City of Palo Alto

City Council Staff Report

Summary Title: Connecting Palo Alto: Project Update and Possible Action on Rail Grade Separation Alternatives

Subject: "New Ideas" from XCAP Technical Working Group

Alexis - Charleston Underpass and Roundabout Layout

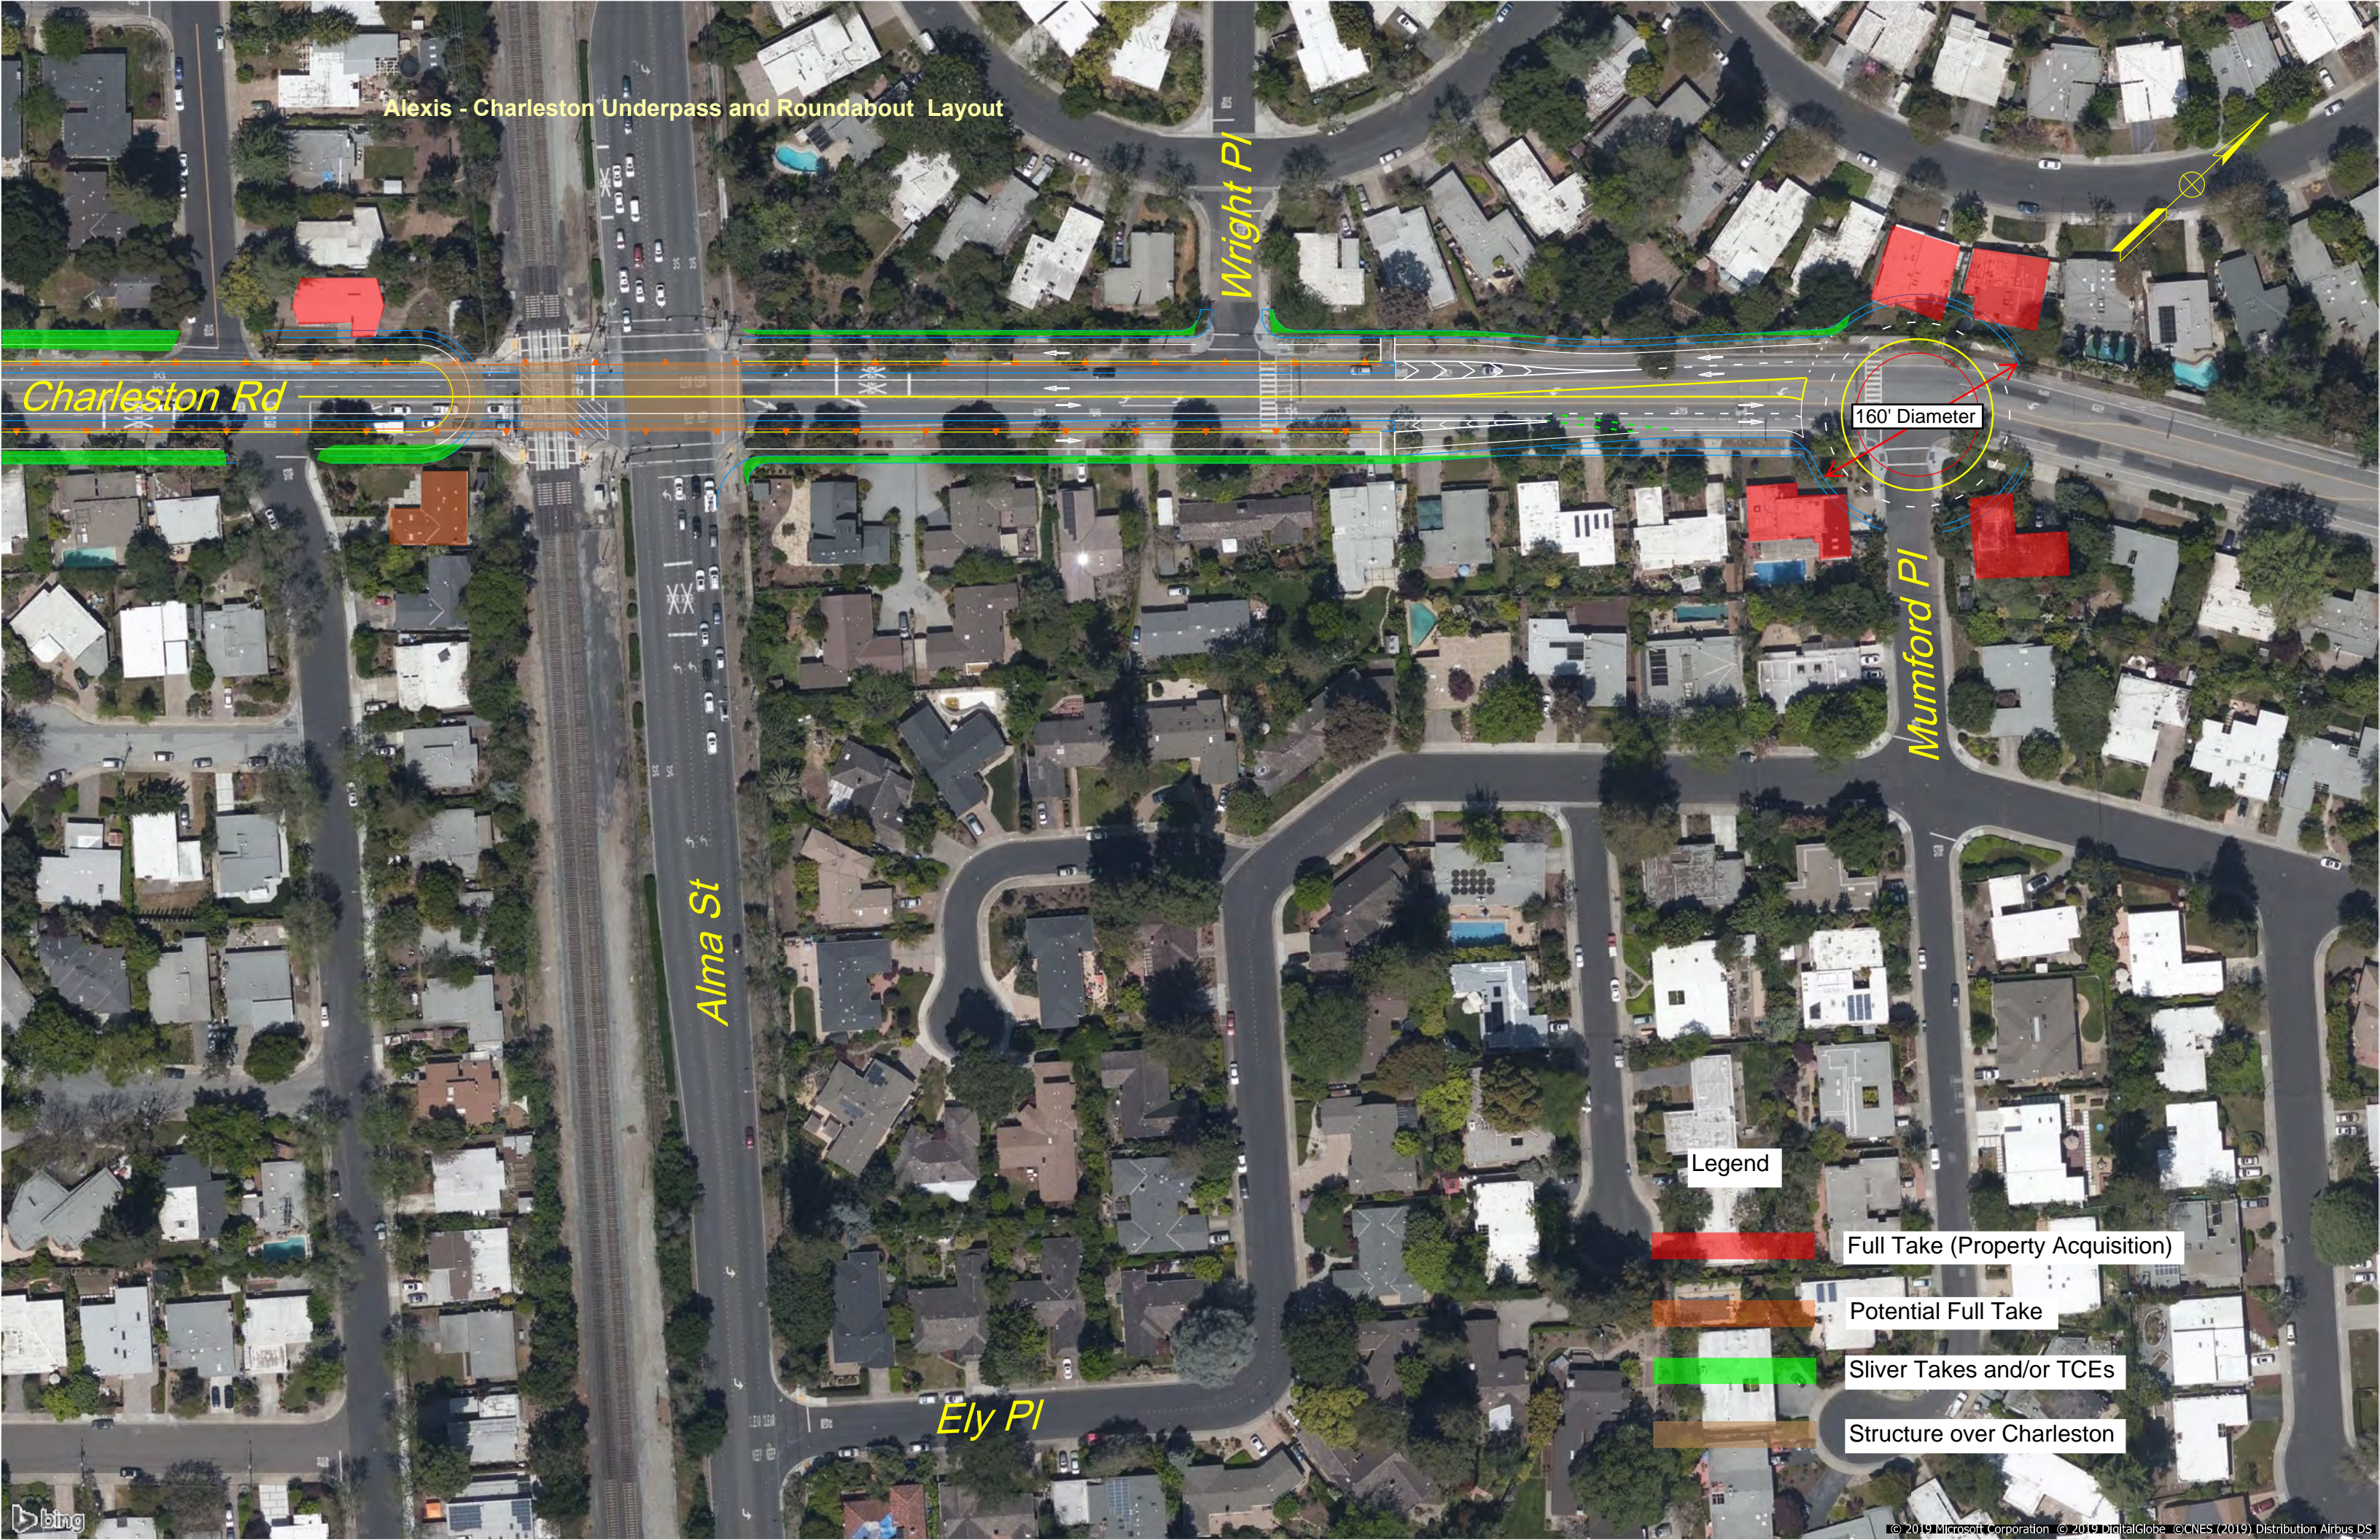
Geometrics/Structures

- The east/west through movements would pass under two structures (one for the railroad, one for Alma St), similar to Embarcadero today.

- Slide 8 does not show standard merge distances, so the footprint (along M/C) would likely be much larger than presented on this slide.
- The existing width of Charleston on the east side of the tracks (from back of sidewalk to back of sidewalk) is approximately 85 feet. To obtain an adequate cross section of the frontage roads and underpass, we need approximately 95 feet of width, which will require a sliver acquisitions on each side of the road (see x-section). The curb setback distance for the homes on the south side Charleston would be reduced by ~ 16 feet.

- Same as other underpass options... a pump station will be needed to drain the lowered roads.

- A circuitous route is proposed for EB vehicles on Charleston and Meadow.
- Traffic on NB and SB Alma St destined for El Camino Real and other locations on the west side of the tracks would also have to traverse a circuitous route. In the NB direction, drivers will likely opt for Ely Pl to access Charleston via Mumford Pl to avoid any backups on Alma St, thus generating more traffic on residential streets.
- Road geometry would have to be hashed out to ensure queuing of vehicles (for the u-turn movement, for example) does not impact through movements.

- The "split" of Meadow and Charleston will create a conflict between peds/bikes and motor vehicles, i.e., peds would be on the outside of the road approaching the railroad, but then cross one lane of (moderately high speed) traffic to get to the inside lane (to enter the underpass section of M/C).
